**AGENDA ITEM
D-3
MARCH 14, 2007**

ACCEPT HETRICK WATERLINE REPLACEMENT PROJECT

CHANGE ORDER

TO: ROB CARNES GROUND UP DESIGN & CONSTRUCTION MANAGEMENT P.O. BOX 1583 PASO ROBLES, CA 93447	<u>C.O. NUMBER</u> #001 REVISED	<u>DATE</u> 2/19/07
JOB LOCATION: HETRICK AVE. WATERLINE REPLACEMENT PROJECT		
JOB NUMBER: 2006-238		
EXISTING CONTRACT NO. 19996	DATE OF ORIGINAL CONTRACT: 12/13/06	
We hereby agree to make the change(s) specified below:		
Per the attached Request for Proposal (PCO #003), Papich Construction will complete the work for the amount below. An itemized breakdown per caltrans standards is attached.

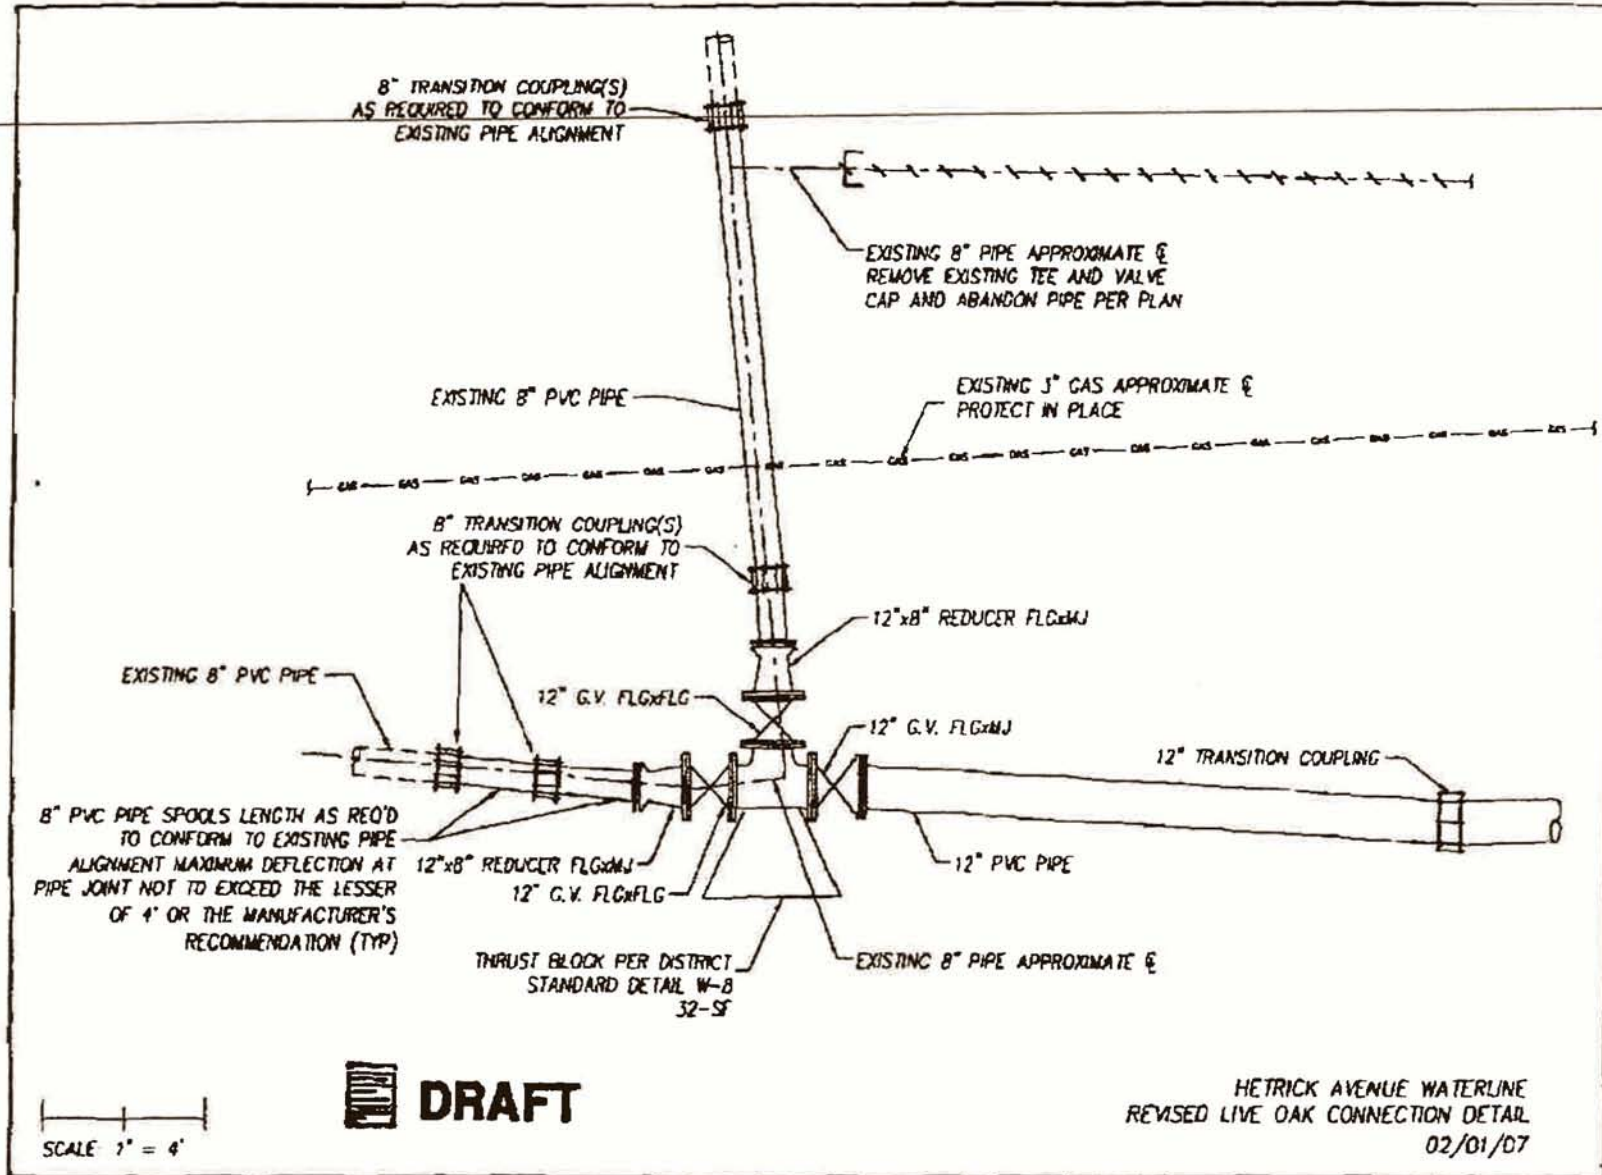
From: ROB CARNES [rwcarnes@earthlink.net]
Sent: Thursday, February 01, 2007 8:28 PM
To: brian@papichconstruction.com
Cc: 'Josh Reynolds'; 'Bruce Buel'
Subject: PAPICH PCO #003: LIVE OAK / HETRICK REVISED TIE IN
Importance: High
Attachments: HetrickLiveOakConnection.pdf; PAPICH PCO #003 LIVE OAK HETRICK TIE IN CHANGES.pdf; TRANSMITTAL.pdf

BRIAN: Please provide a cost (add or deduct) for approval as soon as possible so that we may proceed to install the revised connection. You are not authorized to proceed with out an approved PCO!!!!
